# McLaren Elva – Install Additional Air Duct Sealing – Active Air Management System (AAMS)

**Bulletin type:** Service Campaign  
**Reference number:** SCB 26 A 001  
**Attention:** Retailer Service Managers and Retailer Technicians  
**Affected vehicles:** McLaren Elva  
**Situation:** Potential for excessive wind noise generation from the AAMS duct during higher speed driving  
**Procedure:** Action affected vehicles during next Retailer visit. Please refer to the information outlined in this document to install additional moulded sealing strips across the AAMS duct  
**Date:** 24<sup>th</sup> June 2021

Extract from WI document - Installation position of additional sealing strips

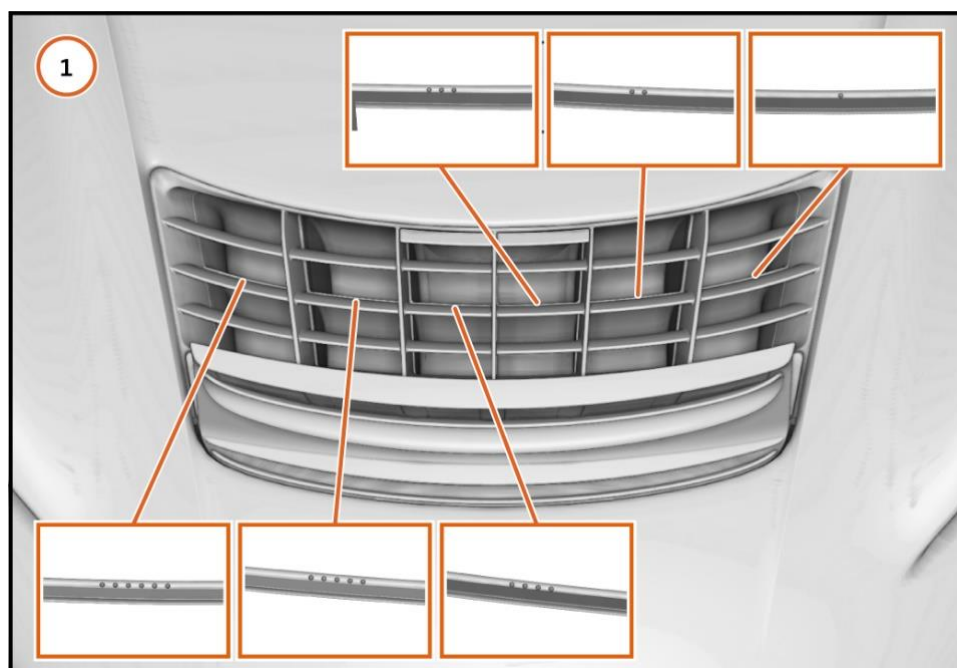
Through continuous product quality monitoring, it has been identified that a known number of McLaren Elva vehicles, have insufficient sealing in the AAMS duct. This could cause a customer complaint of excessive wind noise at higher driving speeds; therefore, a preventive rework solution has been released.

Part Number	Part Description	Quantity Required
26AD315SP	AAMS Duct Finisher Seal (kit containing 6 seals)	1

To perform the required work, document SCB 26 A 001 WI (attached with this Bulletin) contains the relevant work instructions and care points to ensure the required repair is carried out to bring the vehicle up to the latest manufacturing standard.
